Subject: North Burgess Solar Project - Detailed Survey and Reduced Wetland Setback

H334844-0000-07-218-0211, Rev. 0

Subject: North Burgess Solar Project - Revisions to Project Location

Natural Heritage Environmental Impact Study – Figure showing Project Location and Significant Natural Heritage Features
North Burgess Solar Project – Revised Layout

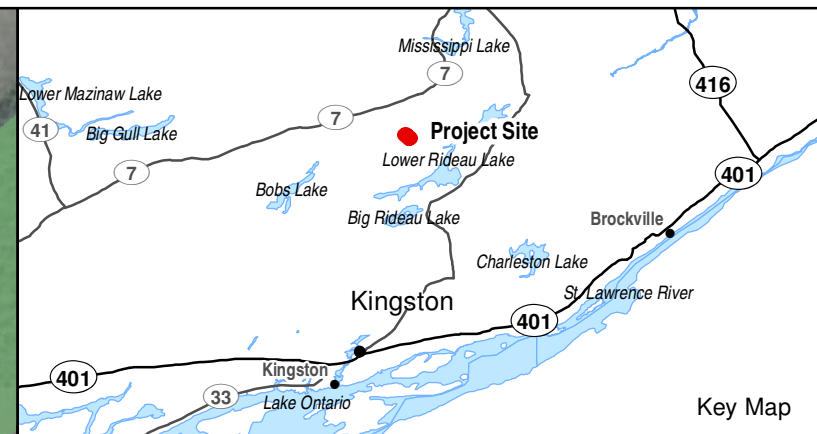
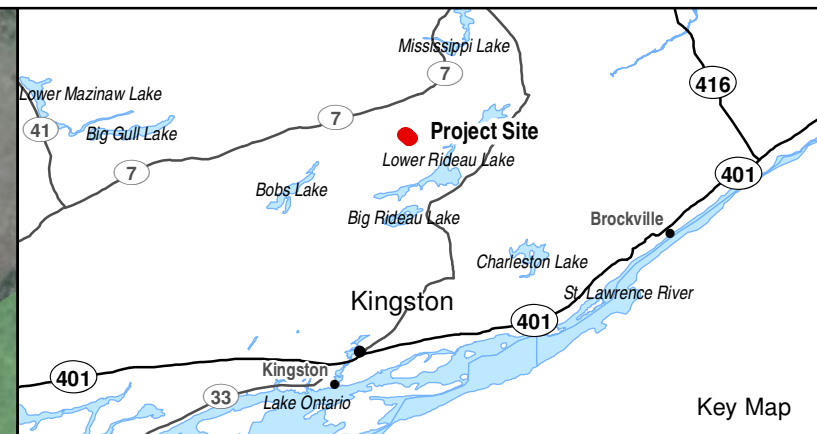
- Setback from the wetland community within Woodland 3 along the northern extent of the southern portion of the wetland to be reduced, in some locations, to 10 m from 30 m. This will occur across a length of approximately 100 m along the wetland.
- Setback from the wetland community within Woodland 3 along the southern extent of the southern portion of the wetland to be reduced, in some locations, to 15 m from 30 m. This will occur across a length of approximately 110 m along the wetland.

- Southern boundary would increase from a 50 m corridor to a 150 to 225 m corridor. This represents a net benefit to wildlife movement.
- Western boundary would be reduced from a 50 m corridor to a 30 m corridor. Though this reduction reduces the overall width of this corridor, a 30 m corridor is anticipated to provide a sufficient buffer for wildlife movement.
- Eastern boundary would decrease from a 25 m corridor to a 5 m corridor.

Attached to this letter, you will find the figure from the Natural Heritage Environmental Impact Study report, revised to show the original Project location, the September 2012 revision to the Project location, and the current proposed revision to the Project location. In addition, the proposed revised layout for the Project is also provided for consideration.

Figure 1.1
 Northland Power Inc.
North Burgess Solar Project
Project Location and Significant Natural Heritage Features

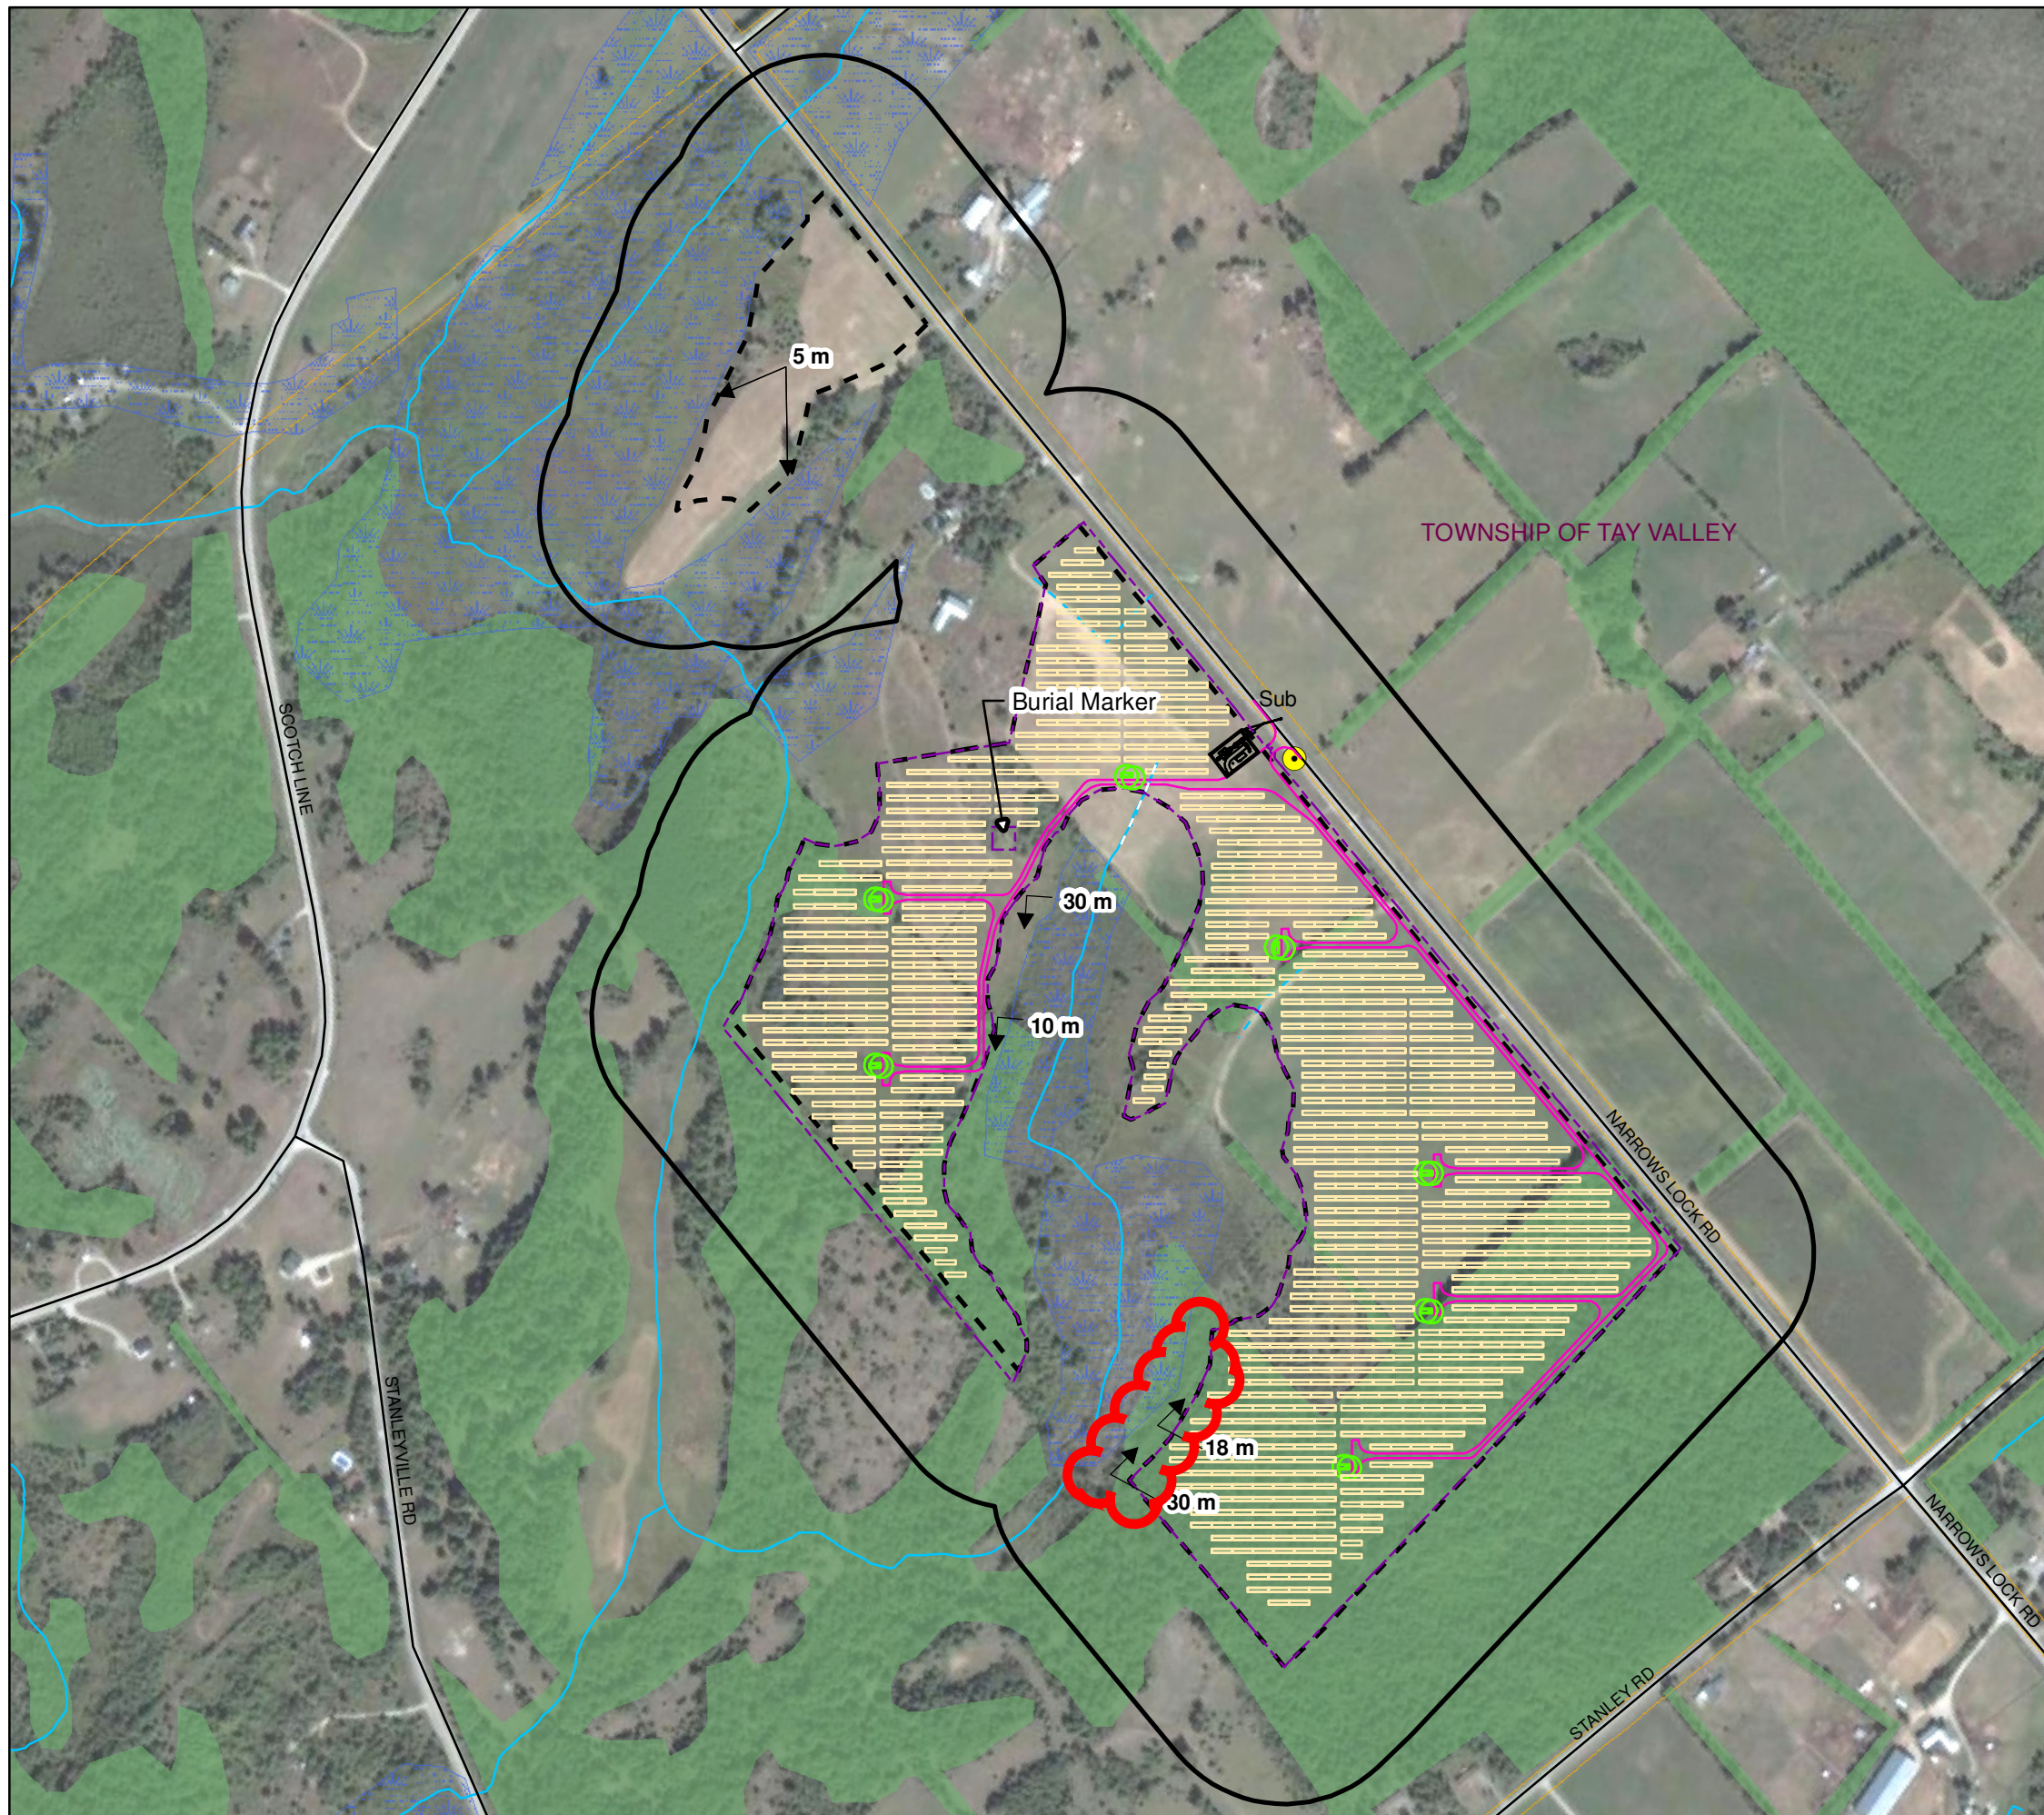
Subsequent to our correspondence of January 22, 2013 (attached), Northland has been completing detailed surveying activities related to construction and clearing activities of the North Burgess Solar Project. During this surveying, it was determined that the previously identified separation between the identified Project location and the wetland community on the southern portion of the site in Woodland 3 is closer to 10 m, rather than the 15 m identified in the January 22, 2013 correspondence and associated figure. The area in question is circled in red on the last page of the previously provided correspondence.

Given that detailed design of the proposed facility has been completed, we are proposing to amend the previously identified setbacks to be reflective of the actual 10 m distance, which has already been confirmed along the northern boundary of this wetland community. Mitigation measures identified within the January 22, 2013 correspondence will be respected in this area as well, and no new impacts to the wetland community are anticipated beyond those identified in the previous correspondence.

Thank you for your memo dated March 26th, 2013. A copy has been added to the North Burgess project file. Please accept this email as confirmation that the proposed setback of 10m from the wetland feature in woodland 3 has been accepted. A copy of this email should be retained for your records.
